CONSERVATION TEAM CONSULTATION APPLICATION RESPONSE

APPLICATION REF:	25/01383/LBC
CASE OFFICER:	SK
APPLICATION SITE:	Highover Farm, Highover Way, Hitchin Hertfordshire SG4 0RQ
DESCRIPTION OF WORKS:	Internal and external alterations to threshing barn to facilitate change of use to 2no. self-contained dwellings (Unit 3 to also include adjacent unlisted, single-storey courtyard building).

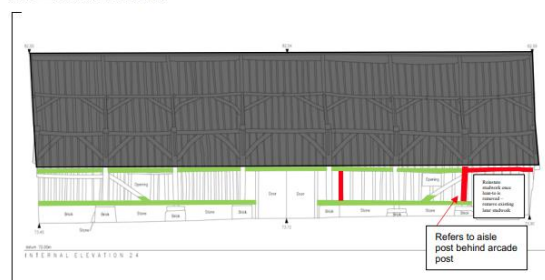
Structural oak frame repairs required internally avoiding steel where possible other than maybe in the construction of the first floor.

*Lower/ground floor windows - discussion fire safety/building regs - alternatives? **Need to consider impact on historic fabric (the timber, sole plate and plinth).** Noted higher plinth in the courtyard compared to the rear elevation. Minimal windows required.*

5.1.6 Internal Elevation 24

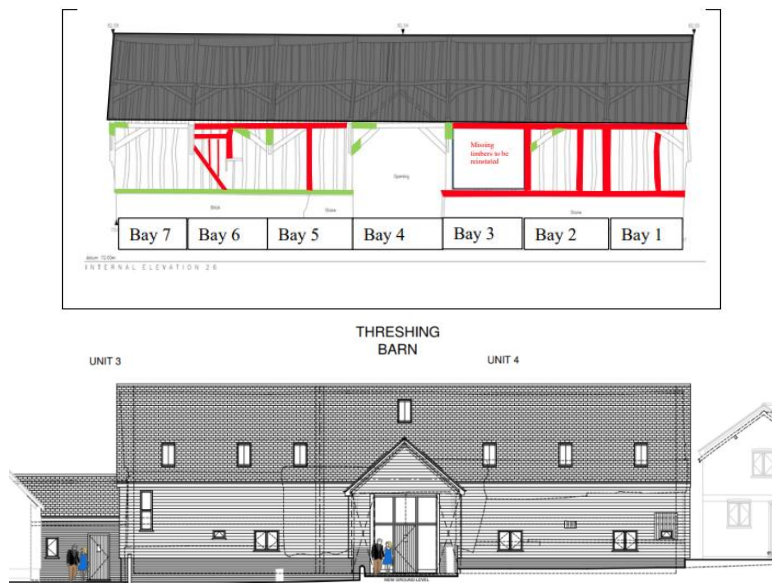
Key here is where the windows sit within the walls – are they intended to be flush with the timber frame or sitting in front of the frame? If it is the former, then there is a concern that several studs would need to be cut to accommodate single and double casements. Whereas, if sitting in front of the framing within the insulated envelope of the building then the studs can be left in-situ. What is unclear, therefore, is the impact of windows on the host building's fabric.

3. Notwithstanding the red coloured timber frame sections identified at 5.1.6 Internal Elevation 24 on page 25 and 5.1.7 Internal Elevation 26 on page 28 of the Heritage Consulting Condition Survey dated 16 June 2025, these frame members and any others identified during further inspections of the frame shall form part of a detailed full inspection with the Local Planning Authority and their removal shall be agreed with the Local Planning Authority prior to the new frame members being formed. Furthermore, where new frame sections are required, these shall be undertaken in oak unless otherwise agreed and approved in writing by the Local Planning Authority.

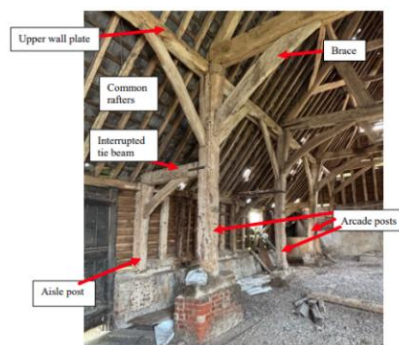
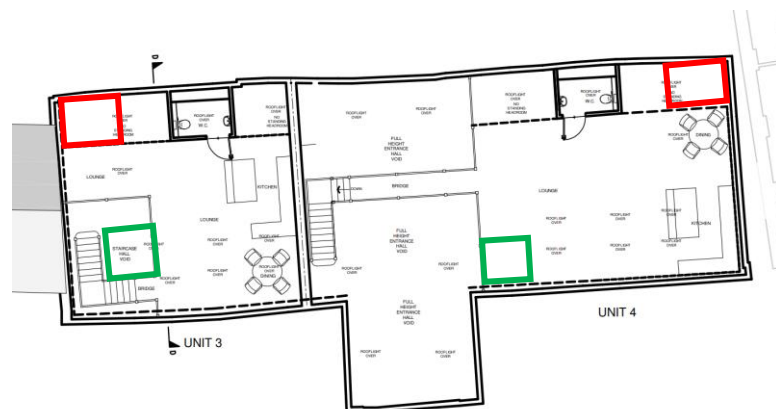
Although building outside of the existing frame is a tried and tested approach for barn conversions, this is rarely in my mind undertaken by cloaking the existing building with a steel structure. Under ref: 24/00413/LBC in relation to a barn at Manor Farm, Kelshall, a similar approach was offered early on, but the decision was taken to seek a solution that did not require either the frame to be rebuilt or the frame to be 'hung' from a steel frame envelope. Instead, an internal steel frame system was consented which effectively stiffened or supported the frame internally and then a timber stud/rafter system in conjunction with insulation was used externally.

I question the approach of cladding a new steel framework and no technical details are provided as to how this might be achieved. An external steel framework approach is not supported unless convincingly justified (see conditions 4 and 5 below).

4. Notwithstanding reference to '*a new steel frame is to be erected in front of the existing timber frame*' at 4.1 of the Heritage Consulting Condition Survey (16 June 2025), full structural details of all steelwork shall be submitted to and approved in writing by the Local Planning Authority prior to the commencement of any steel work. Thereafter the steel work shall be undertaken in accordance with the approved details.
